Amendment 78 to
DPR-16

SUBJECT: ADMINISTRATIVE CONTROLS

Re: Oyster Creek Nuclear Generating Station

SAFETY EVALUATION BY THE OFFICE OF NUCLEAR REACTOR REGULATION
SUPPORTING AMENDMENT NO. 78 TO PROVISIONAL OPERATING LICENSE NO. DPR-16

FIGURE 6.22
ONSITE ORGANIZATION

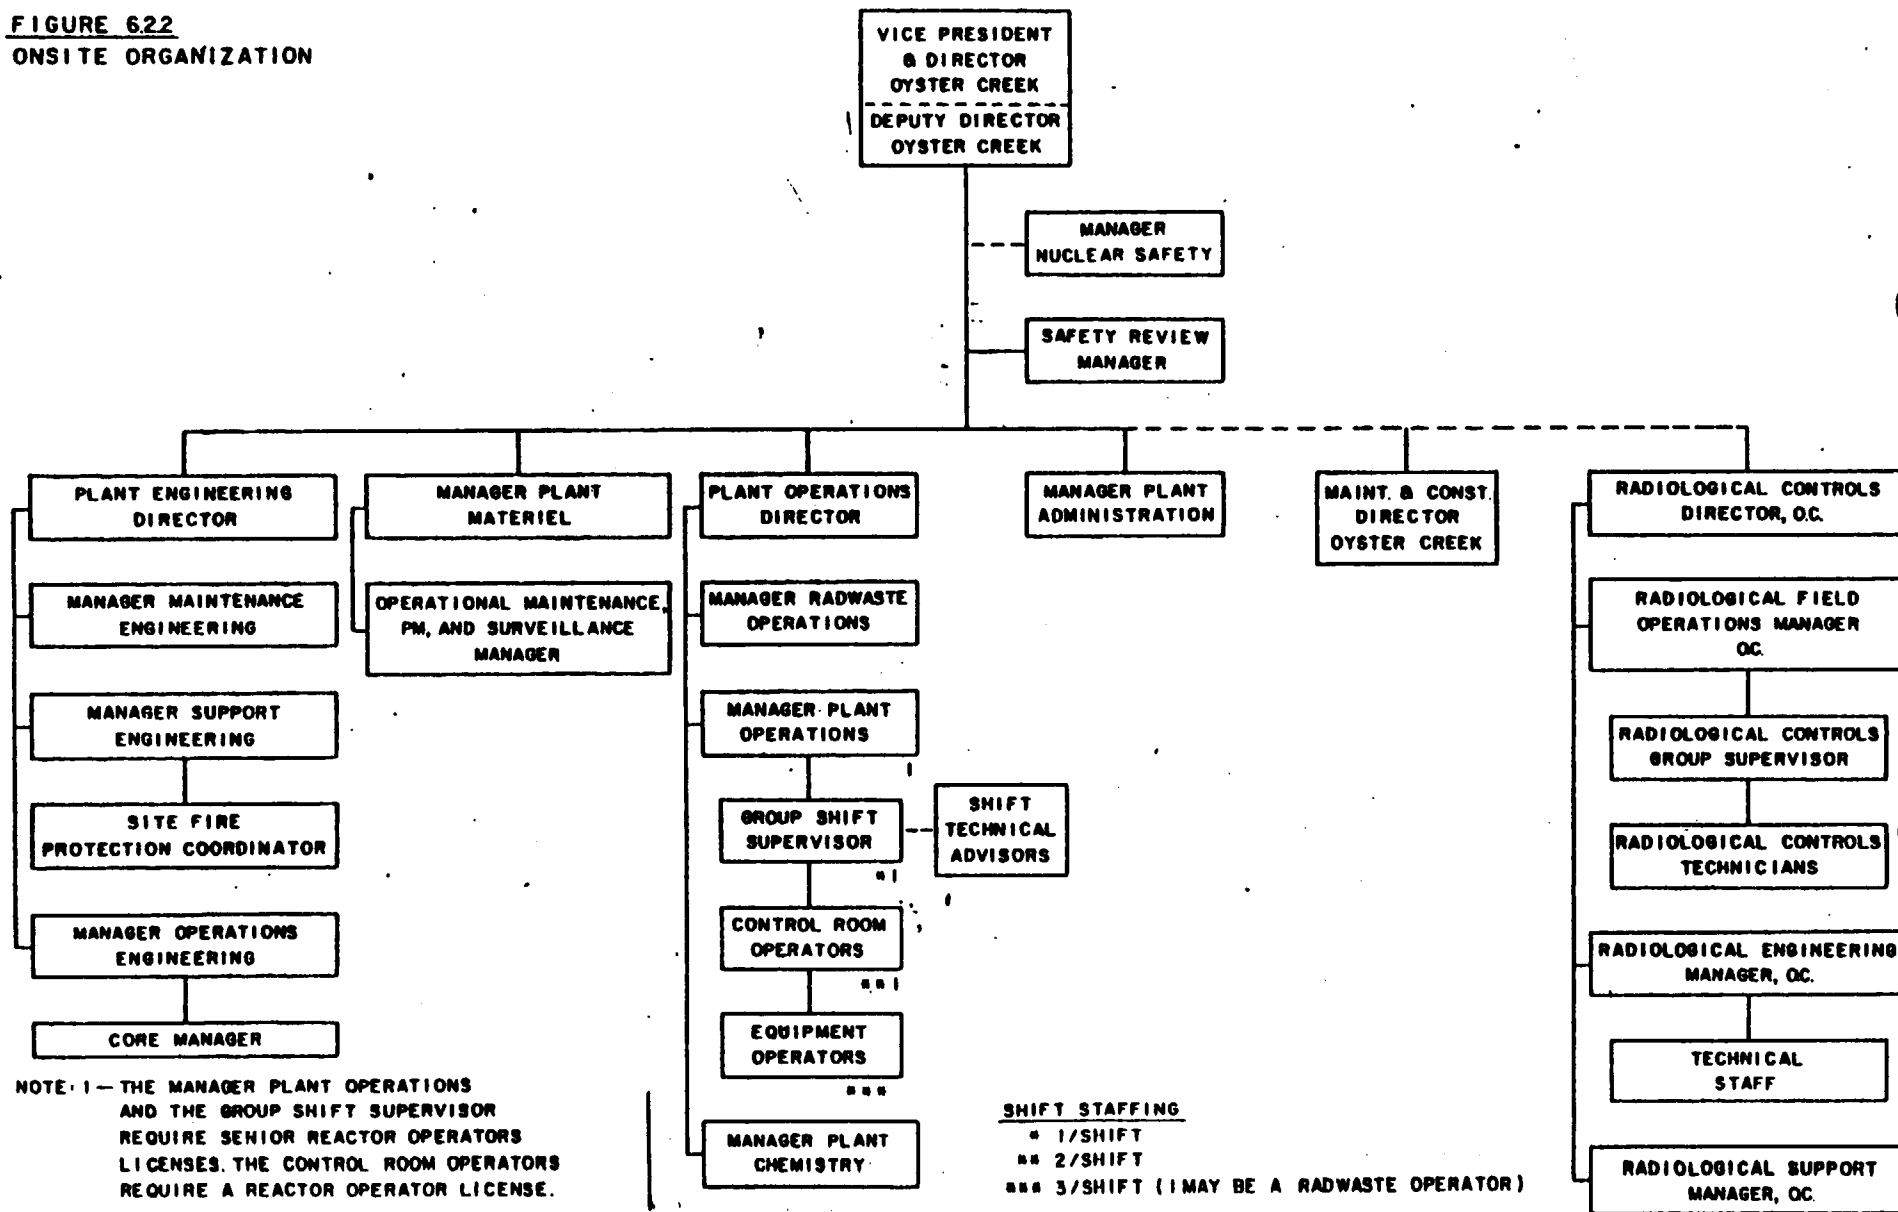
The Plant Engineering organization will be restructured as depicted in revised Figure 6.2.2 and as described in revised Section 6.3.1. The responsibilities of the Manager-Plant Engineering will be split into three separate areas: Operations Engineering, Maintenance Engineering and Support Engineering. Each of the three areas will be headed by a Manager

The Fire Protection Supervisor title will be revised to Site Fire Protection Coordinator since this position no longer directly supervises the activities of fire protection personnel. This position reports to the Manager-Support Engineering, but continues direct access to the Plant Engineering Director providing an additional level of technical support to this function. Since the technical responsibilities of the position remain the same, the staff finds this proposed administrative change acceptable.

The title of Manager-Core Engineering will be revised to Core Manager. This position reports directly to the Manager-Operations Engineering and relieves this position of some administrative responsibilities which allows more time for technical duties. An additional level of expertise is also provided to the Plant Engineering Director. The description of the Core Manager has been placed in a new place on TS page 6-6 because the position now ranks at a different level in the facility staff organization. Since the technical responsibilities of this position remain as specified in Section 6.3, the staff finds this proposed administrative change acceptable.

The position of Chemistry Manager no longer falls under the cognizance of the Plant Engineering organization. This position now reports to the Plant Operations Director and is subsequently deleted from Plant Engineering; this title has also been changed to Manager-Plant Chemistry. The description of the Manager-Plant Chemistry has been moved from the bottom of TS page 6-6 to the bottom of TS page 6-5 because the position now ranks at a higher level in the facility staff organization. Since the qualifications of this position remain the same and the position's reporting requirements have not been downgraded, the staff finds this administrative change acceptable.

Another change to the onsite organization at Oyster Creek is that the position of Manager/Deputy Radiological Controls has been upgraded to the Director level. The title of the position will be revised from Manager/Deputy Radiological Controls to Radiological Controls Director. This revision in titles will also be made in TS Section 6.3.2 which has a reference to the Manager/Deputy Radiological Controls. The TS requirements and reporting requirements remain the same for this position; therefore the staff finds these administrative changes acceptable.
